<u>Feb 17, 2014</u>	EVE-09-03	<ul style="list-style-type: none"> • <u>Revisions based on feedback from: EVE-08 meeting (Action 2, Action 6, and Japan comments) and those received after the EVE-8 meeting (China, VPSD Chair, and OICA).</u>

Electric Vehicle Regulatory Reference Guide [DRAFT 43]

Prepared for: **The United Nations Economic Commission for Europe (UNECE) Electric Vehicles and the Environment Informal Working Group (EVE IWG)**

Prepared by: **The EVE IWG, with support from FEV, Inc. and Energy Solutions**

Figure 8 : Electric vehicle-range requirements, world-wide view

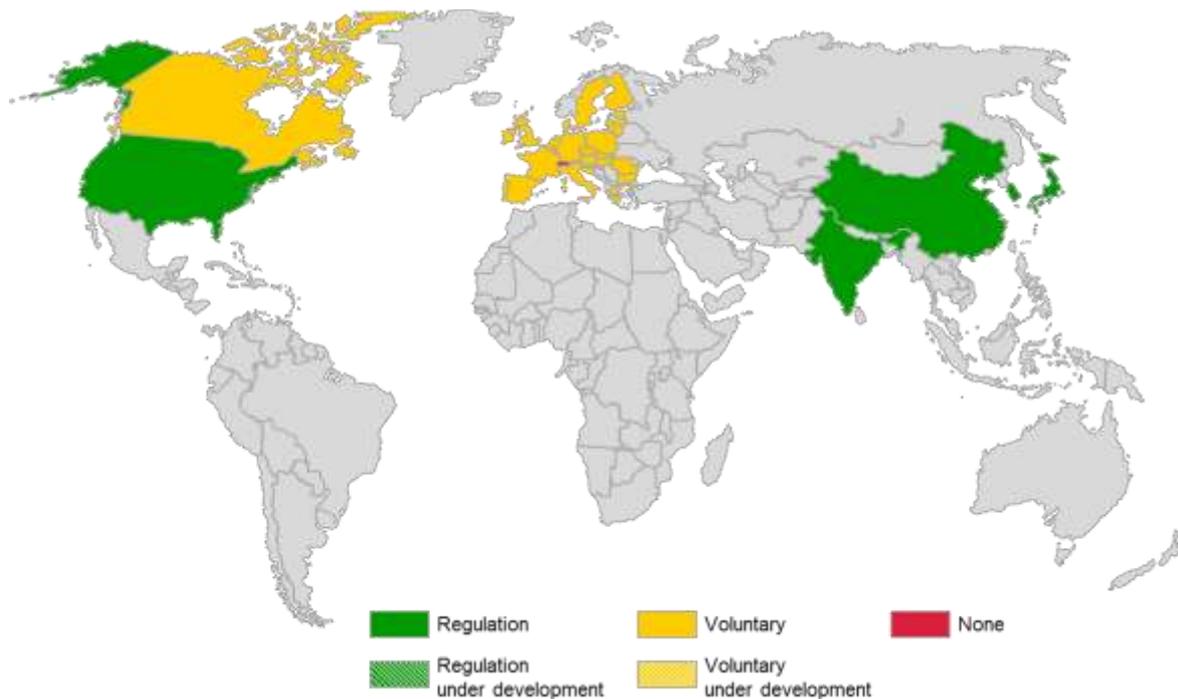
Electrified vehicle range is widely regulated. [*OICA comment: Doesn't look so widely regulated from the map; Text is confusing – clarify whether means test procedure or minimum range requirements.*] A memorandum of understanding is in place between the Government of Canada and industry for the purposes of vehicle labeling only, which involves range determination. China has a voluntary Chinese National Standard that is available for adherence to (GB/T 18386-2005), which is quoted in the regulation 'Management Rules for New Energy Vehicle Production Enterprises and Product Access', and thus recognized as mandatory. The European Union determines range in accordance with UN-R-ECE 101, Annex 9 with respect to light duty motor vehicles and has custom-tailored these electric range requirements for L-category vehiclesⁱⁱⁱ. India has adopted many aspects of UN-R-ECE 101, Annex 9 in its own test procedure (AIS 040). Japan specifies its own test procedure based on the JC08 dynamometer test cycle (TRIAS 99-011-01). South Korea employs a procedure similar to that of the US EPA/NHTSA (described below). Switzerland does not specify any regulations or voluntary standards in regards to electrified vehicle range. The SAE J1634 recommended practice has been adopted as the test procedure for the US EPA/NHTSA. The California Air Resources Board (ARB) has its own range test procedure employed in determination of allowance credits in connection with its Zero Emission Vehicle (ZEV) Regulation.

Figure 10 : Electrified vehicle driver-user information requirements, world-wide view

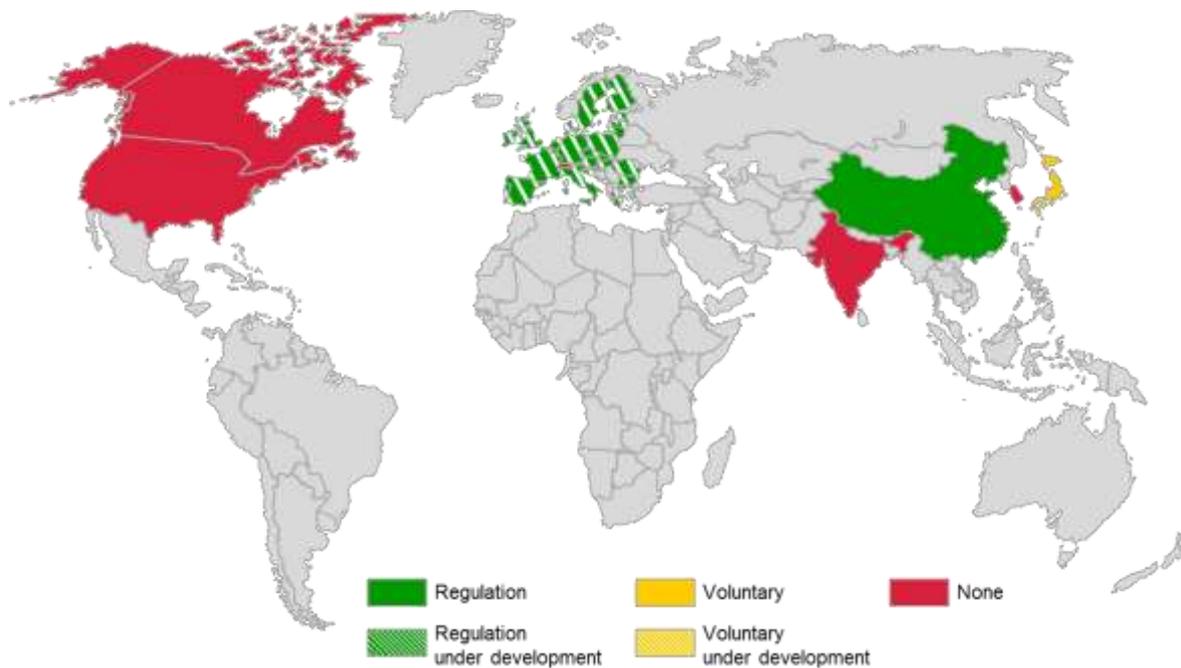
GRPE) [OICA comment: See accompanying comment document for additional points]

[OICA comment: Definition not clear]

Figure 12 : Vehicle labeling requirements, world-wide view

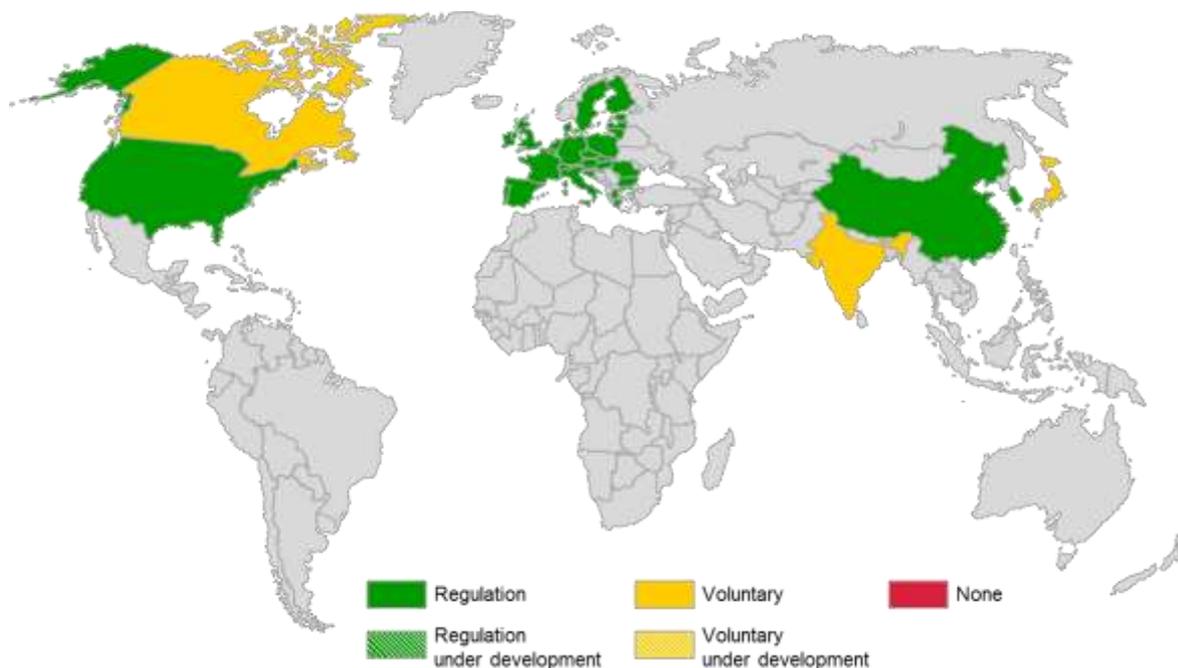
3.63.5 Vehicle Labeling [OICA comment: Study from EU shows labels don't move the needle, actual taxation has greater effect on consumer behaviour.]

~~vehicles at this time.~~ **[OICA comment: or is this meant to refer exclusively to L category vehicles?]**

Figure 13 : Battery attributes, global snapshot

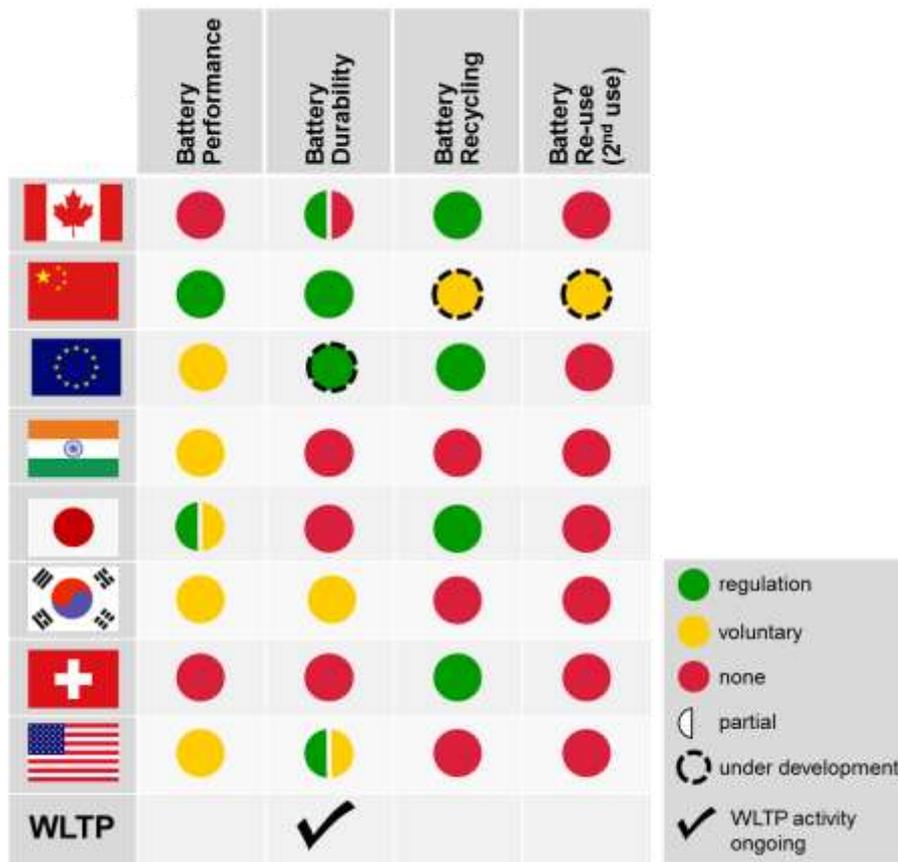
Battery Attributes **[OICA comment: Not clear what voluntary standards are here]**

Figure 13 provides a global overview of requirements from the standpoint of battery attributes. The following sections will discuss each attribute in detail. *[OICA comments (2): WLTP battery durability – not defined if in or out of Phase 2 scope discussions – however, there is an opportunity to discuss scope in 2015; Not aware that EU has battery performance voluntary measures.]*

Figure 14 : Battery performance requirements, world-wide view

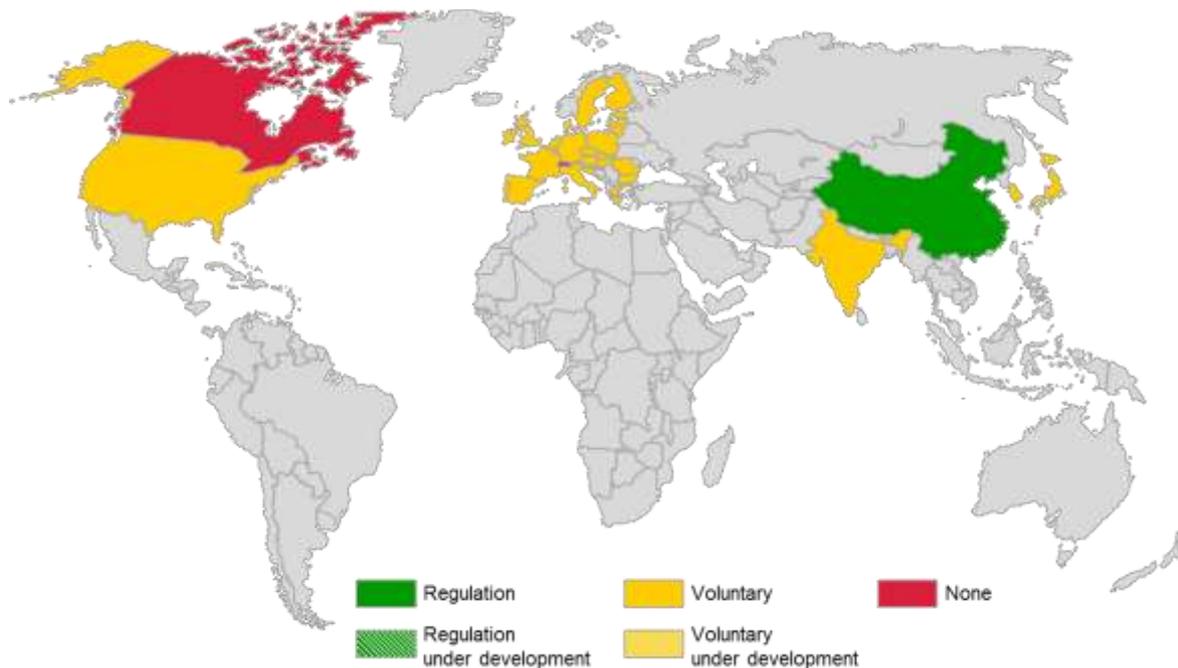
Attribute Definition: *Methods and conditions for testing and measuring battery power delivery capability, energy storage capacity, battery charge, etc. [OICA comment: Not entirely clear what is meant by battery performance]*

Figure 16 : Battery recycling requirements, world-wide view

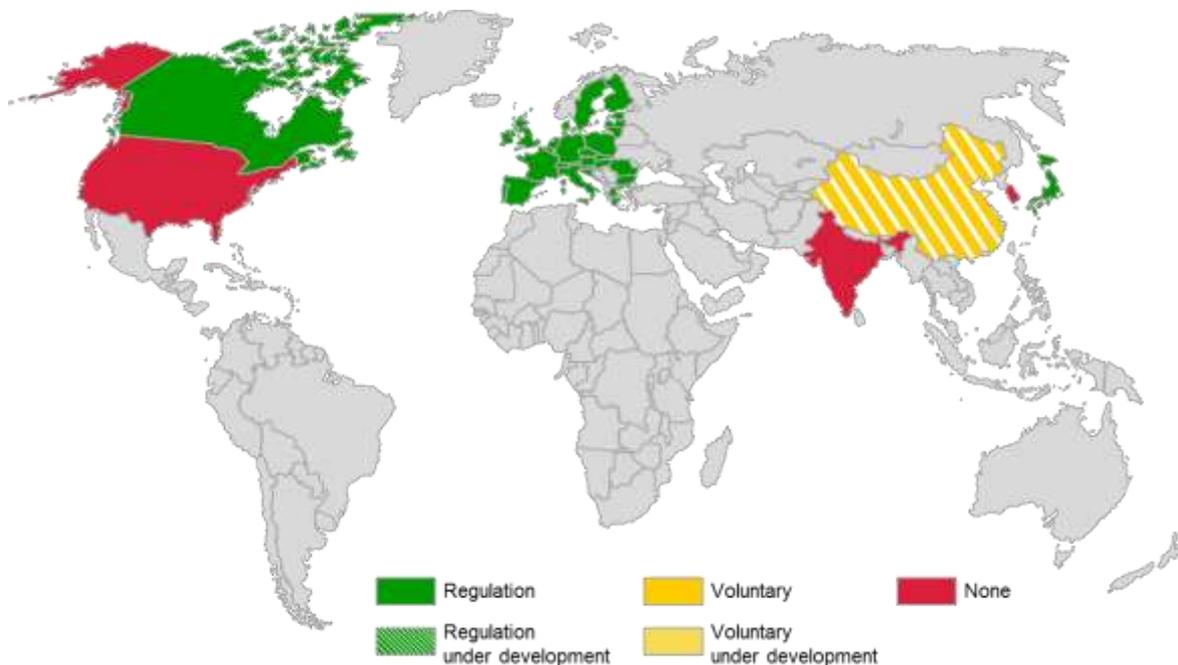
Attribute Definition: Battery material recycling standards. **[OICA comment: See accompanying comment document. We believe existing regulations are effective and no gap exists in reality]**

Figure 24 : Vehicle as electricity supply requirements, world-wide view

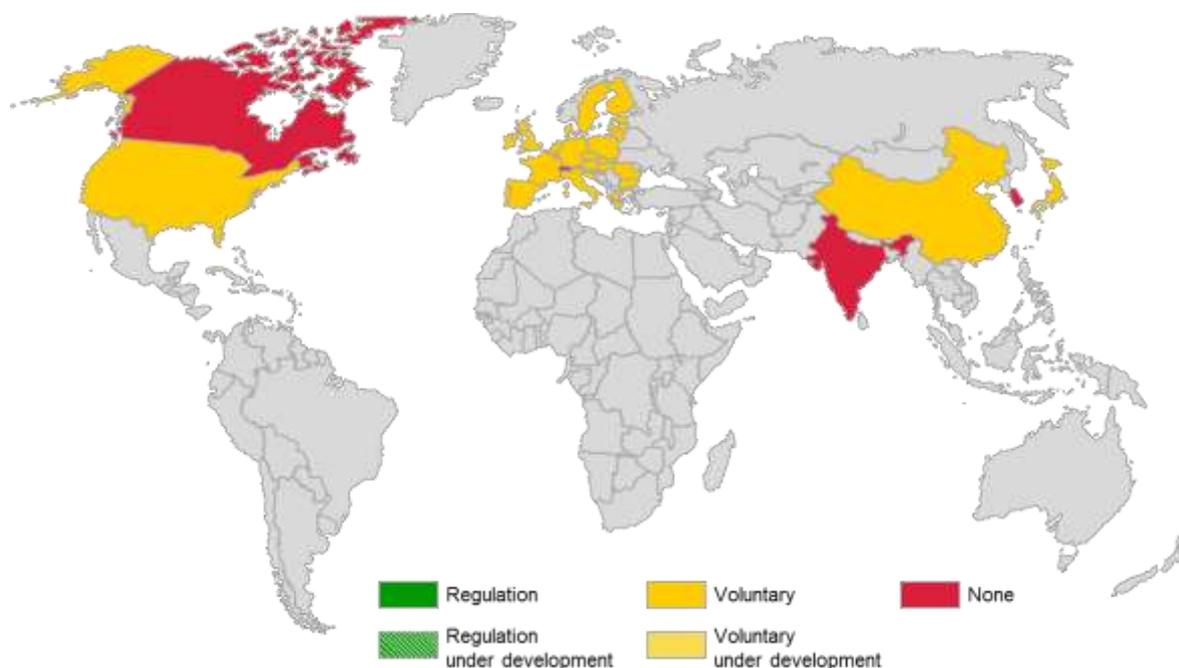
Attribute Definition: Vehicle-related specifications and requirements for transferring electricity from EVs to the grid. *[OICA comment: See accompanying comment document – this section appears to be prejudging the need for regulation. There are many aspects not only technical to consider here before regulation.]*
